Request for Decision

Sitiri Investments Ltd. (Agent: Dalron Construction Limited) - Application to amend draft plan of subdivision and rezoning approval (Algonquin Subdivision, Sudbury)

Presented To:	Planning Committee
Presented:	Monday, Mar 20, 2017
Report Date	Wednesday, Mar 01, 2017
Type:	Routine Management Reports
File Number:	780-6/12004

APPROVED DRAFT PLAN

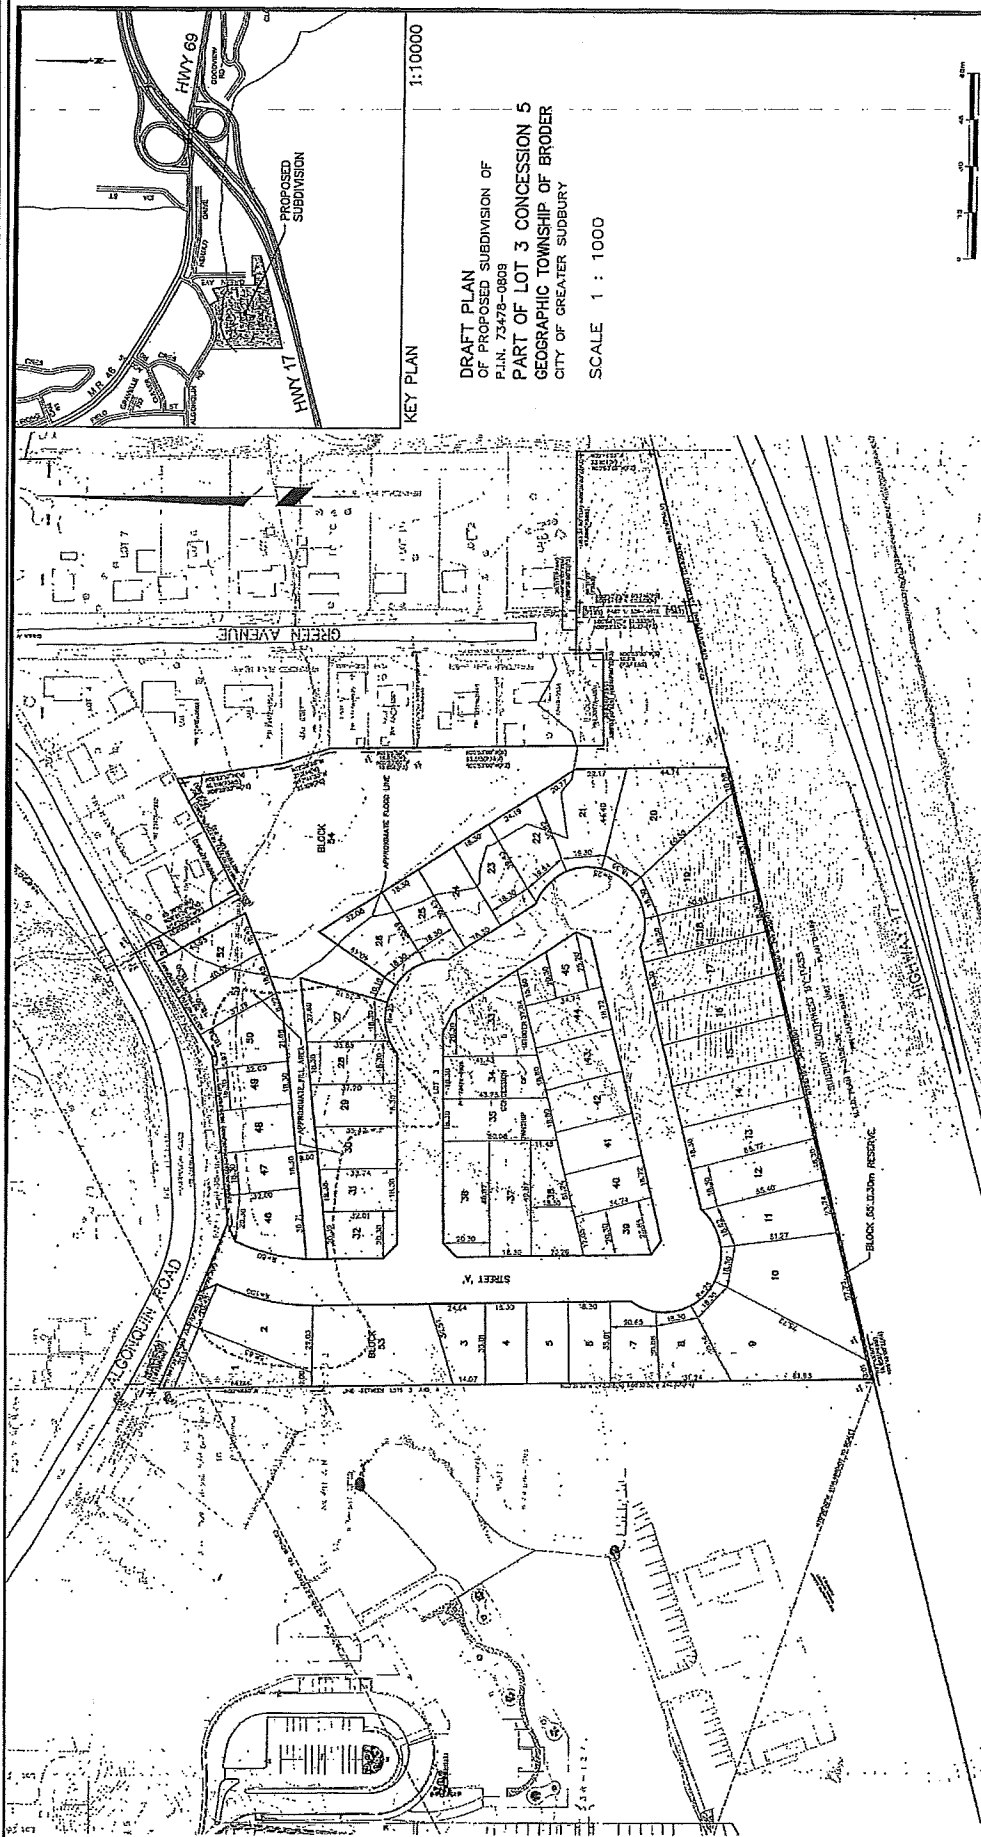
The current draft plan comprises 8 lots for single residential use and 44 lots for double residential use. The owner is now proposing a reconfigured road and lot fabric to accommodate improved sight lines for the road connection to Algonquin Road. The revised plan illustrates 10 lots for single residential use and 44 lots for double residential use, resulting in an increase of two (2) residential lots.

There are no concerns from a land use perspective given the minor increase in the number of lots. The revised plan is essentially a mirror image of the existing plan. The proposed uses, comprising a mix of single and double residential dwellings, remain as before.

The pedestrian walkway to the school property abutting to the west is deleted at the request of Sudbury Catholic District School Board. It has been determined that a walkway is not feasible at that location due to the difficult topography. It is noted that a sidewalk is required on the south side of Algonquin Road linking the proposed development to the school property.

a) That Condition #1 be deleted and replaced with the following:

"1. That this draft approval applies to the draft plan of subdivision of Part of PIN 73478-0809, Part of Parcel 11257 S.E.S., Parts 1-3, 53R-19865 in Lot 3, Concession 5, Township of Broder as shown on a plan of subdivision prepared by Terry Del Bosco, O.L.S., and dated August 16, 2012, as amended by a plan prepared by Terry Del Bosco, O.L.S., and dated January 11, 2017."

PROPOSED DRAFT PLAN

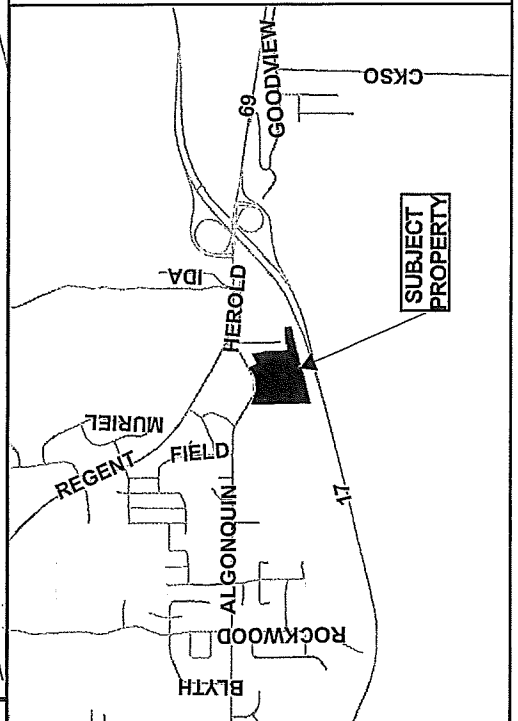
Roads and Transportation Section have no objection to the revised road layout in order to accommodate improved sight lines.

Leisure Services concurs with the revised park layout and other lands to be transferred for public purposes. The Director of Leisure Services recommends that the owner arrange a meeting with the department in order to discuss the development of a neighbourhood park, as per the initial approval in 2013.

“2. That the lands on the amended draft plan of subdivision dated January 11, 2017 be rezoned as follows:

i) Lots 1 to 10 be zoned as “R1-5”, Low Density Residential One;

ii) Lots 11 to 54 be zoned as “R2-2(S)”, Low Density Residential Two Special; and,

iii) Blocks 55 and 56 and the lot identified as “City Parkland” be zoned as “P”, Park.
